**Volvo Car USA LLC****Quality Bulletin**

Bulletin Title Service Action A10246: Leaf Spring Inspect-Repair Model Year 2023 S60, V60, V60CC, V90CC, S90L, XC60, XC90		Group 72	NO A10246
Issuer (Dept.) Product, Safety and Compliance	Car Market United States and Canada	Issue Date 9/26/23	Status Date 12/1/23
Revisions Updated with new content		Page Page 1 of 4

**Leaf Spring Serial Number “sticker” is missing**

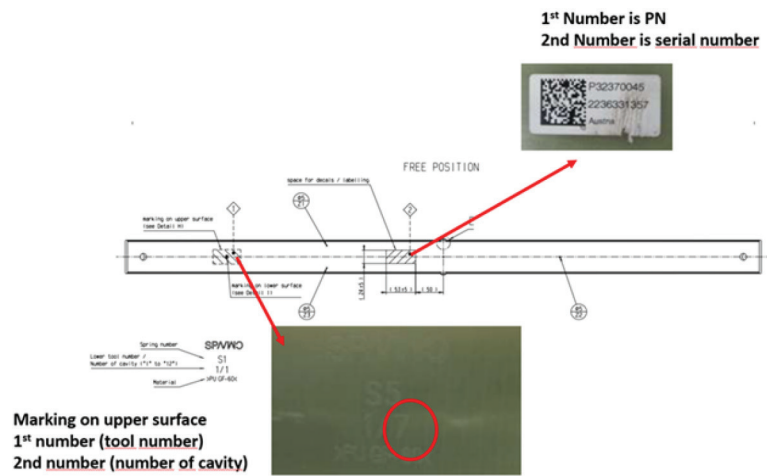
In rare cases where the Serial Number “sticker” is missing please follow the below instructions:

1. Inspect the “tool cavity” molded to the part (See circled Below). The Cavity is the second number in sequence i.e., 1/7.

2. If the cavity **shows** a **6 or 7**, the leaf spring should be **replaced**.
3. If the cavity **does not show** a **6 or 7**, the leaf spring is OK and should **not be replaced**.

**Please note: The cavity mold can be read with mirror.**
